<b>Office Action Summary</b>	<b>Application No.</b> 10/540,661	<b>Applicant(s)</b> NEIGHBOURS, GREGORY JOHN	
	<b>Examiner</b> Adriana Figueroa	<b>Art Unit</b> 3633

1. Applicant's election without traverse of Group I, "a system, a method and a jack for lifting a concrete slab" in the reply filed on 01/10/2008 is acknowledged.

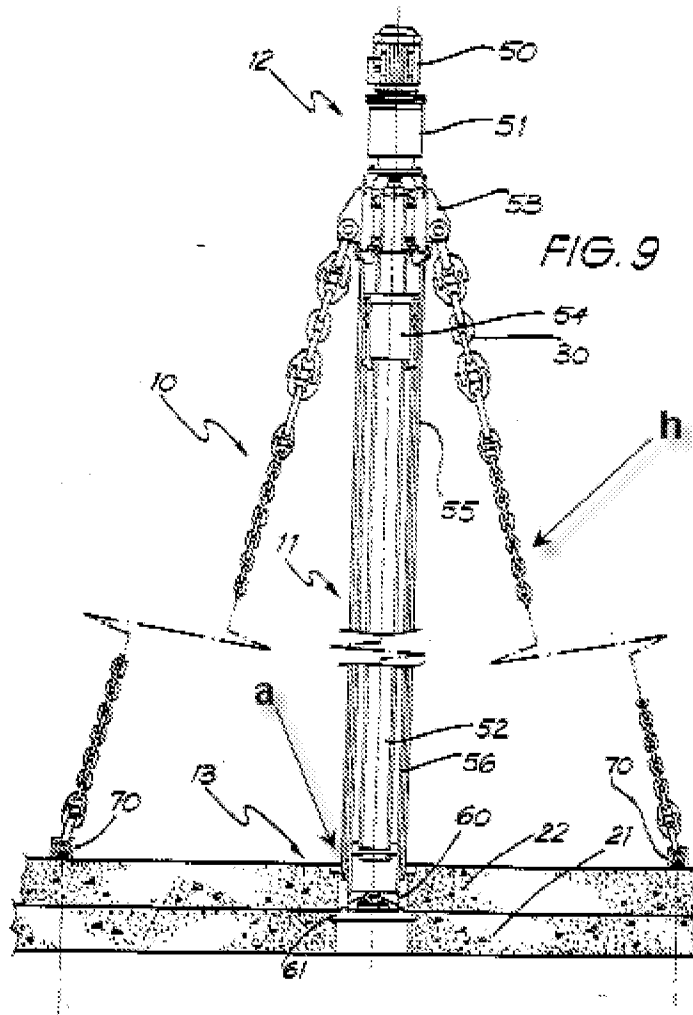
Regarding claim 1, Neighbours discloses a system of lifting and conveying a concrete slab (22) and any associated works, wherein the slab has a plurality of apertures (a) therethrough the slab area, (Figure 1, annotated Figure 9), the said apertures being provided with a respective jack (10), said jack at least comprising at least one shaft (11) having a portion passing through said aperture and contacting a lower support means (40, 41), (Column 5, Lines 1-8), means (30, 51, 53, 55) for connecting said slab to said shaft, (annotated Figure 9),

the connection means incorporating at least one supporting member (30) connecting the slab (22) to the shaft (11), and means (50) for effecting longitudinal travel of said supporting means (30, 51, 53, 55) along said shaft, otherwise resulting in the raising or lowering of said slab, (annotated Figure 9), position sensors associated

Regarding claim 2, Neighbours discloses the jack (10) including trailing restraint means (55, 56) being adapted to provide restraint and or stability for the jack once it has climbed or the jack has been disconnected from the slab, (Figure 9), (Col 6, Lines 66-67, Column 7, Lines 1-3).

Regarding claim 7, Neighbours discloses each supporting member (30) engages with the upper face of the slab (22), (Figure 9).

Regarding claim 8, Neighbours discloses each jack (10) having pivoting means (p) such that in use each jack can accommodate displacement of the jack whereby there is a minimum transfer of moment through any tensile members, (annotated Figure 9).

Regarding claim 25, Neighbours discloses a jack (10) for lifting a concrete slab (22) , the jack including: at least one shaft (11) and ball screw (52), a drive assembly (12), a hanger assembly (h), a support device(40, 41) wherein the drive assembly drives the ball screw to raise the shaft with respect to the hanger assembly wherein, the support device supports the shaft to prevent toppling and provide stability, (Figure 1, annotated Figure 9).

Regarding claim 26, Neighbours discloses the drive assembly (12) further drives the ball screw (52) to raise the hanger assembly (h) with respect to the shaft (11) such that in use the jack has lifted a slab (22), (annotated Figure 9).
